Stage :-		Householder Planning	
Project Title :-		Proposed Roof Change To Existing Single Storey Side & Rear Extensions Including New Roof Lights To The Rear Elevation.	
Drawing Title :-		Existing & Proposed Plans & Elevations	
Client :-		Mrs Nicolson	
Drwg No :-	1 of 2	Date :-	Rev :-
01/25/07		Jan '25	Rev B
Scale :-	Drawn:-	Checked :-	
1:100 & 1:50@A1	SCM		
Site Address :-		7 Rippenden Avenue, Chorlton-cum-Hardy, M21 9SS	
The Old Post Room 34 Chew Valley Road Greenfield Saddleworth OL3 7DA Tel: 01457 871202 www.william-mccall.com enquiries@william-mccall.com		 	
		A1

Proposed Front Elevation

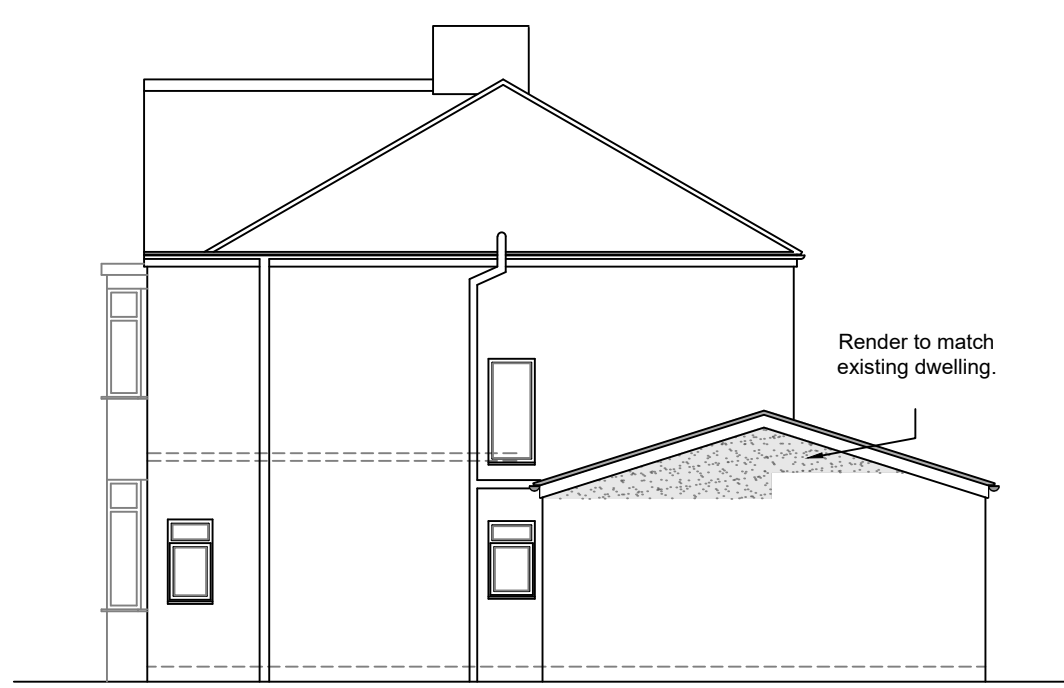
19/03/25 - Rev A - Roof light to front elevation & roof tile details annotated as per the planning officers comments.

Proposed First Floor Plan

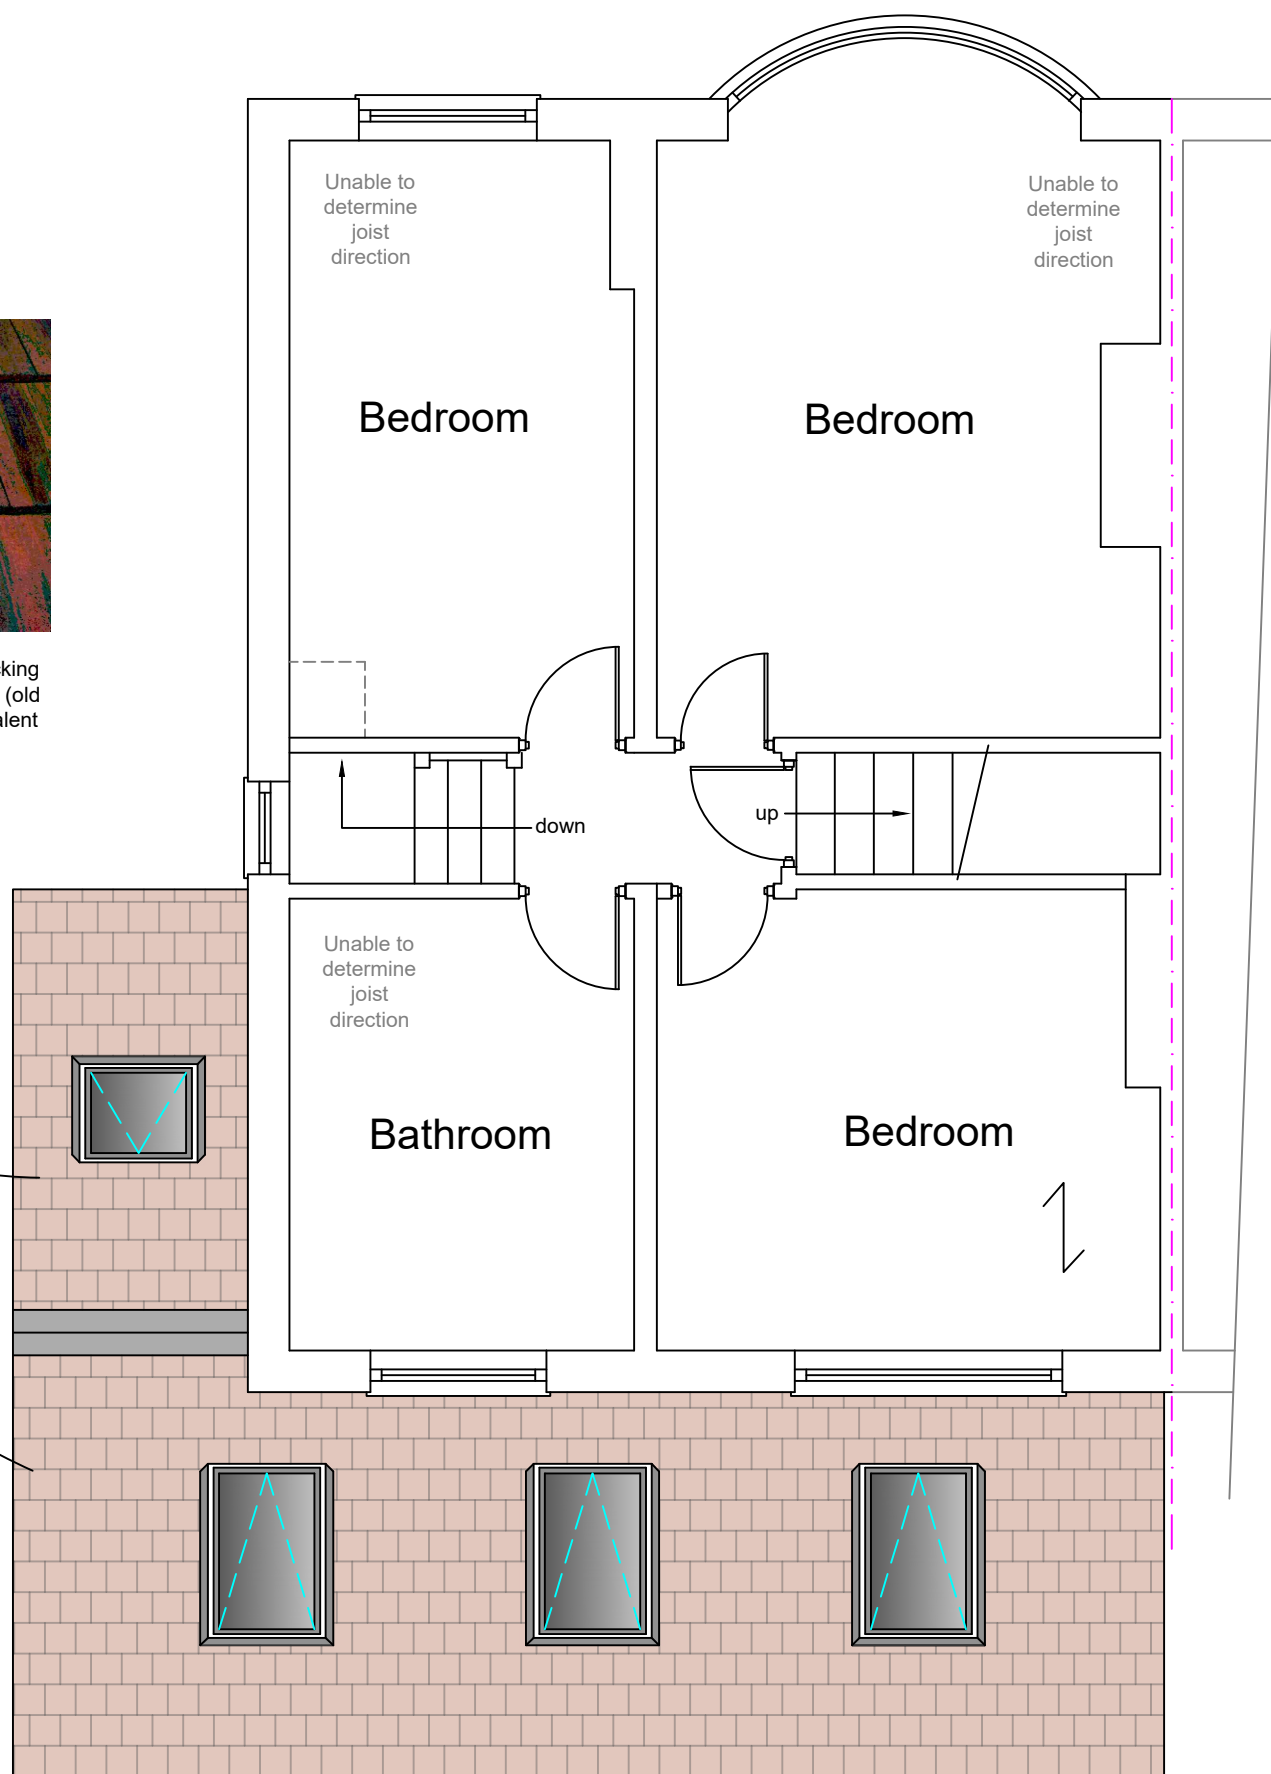
Marley Edgemere Interlocking Roofing Roof Slate Tile (old english dark red) or equivalent
